REPLY COMMENTS OF DUKE ENERGY INDIANA REGARDING THE COMPANY'S 2018 INTEGRATED RESOURCE PLAN

On July 1, 2019, Duke Energy Indiana submitted its 2018 Integrated Resource Plan (“IRP”) to the Indiana Utility Regulatory Commission (“Commission”). The Company’s process included a six-meeting stakeholder engagement process in which the Company and participants discussed the methodologies and assumptions utilized in the IRP modeling and the results of that modeling prior to finalizing the IRP. Duke Energy Indiana seriously considered and responded to stakeholder comments throughout the process, as documented in the IRP. In accordance with the IRP rules, additional comments have been received from the Commission’s Director of Research, Policy and Planning, Dr. Bradley Borum, and a group of stakeholders – the Clean Grid Alliance, Indiana Advanced Energy Economy, Indiana Coal Council, the OUCC, the Industrial Group, and the Joint Commenters. Duke Energy Indiana is providing responses to both sets of comments in this document.

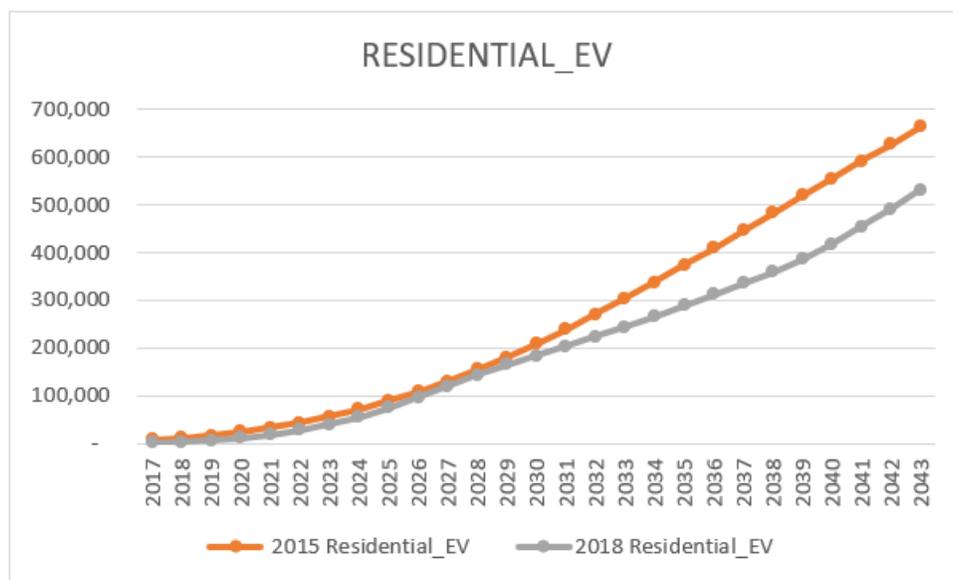
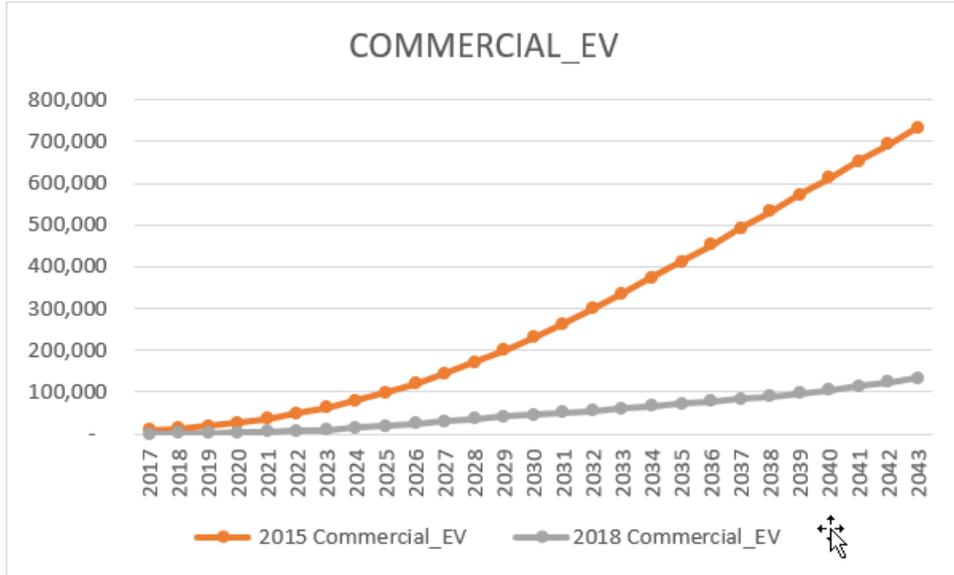
Dr. Borum stated that, in prior IRPs, the Company provided more information and detail about its load forecasting methodology. After reading the IRP, Dr. Borum was left wondering what revisions, if any, were made to the Company’s load forecast for the 2018 IRP. Specifically, what were the impacts of electric vehicle penetration and distributed energy resources on the load forecast. Did ITRON forecast changes to industrial, street lighting and public authority loads?

The current load forecast shows slower electric vehicle adoption, especially in the commercial class. The adoption rates are informed by EPRI’s long-term electric vehicle forecast and recent trends in actual vehicle registrations. See the following two tables representing electric vehicle adoption in the residential and commercial classes.
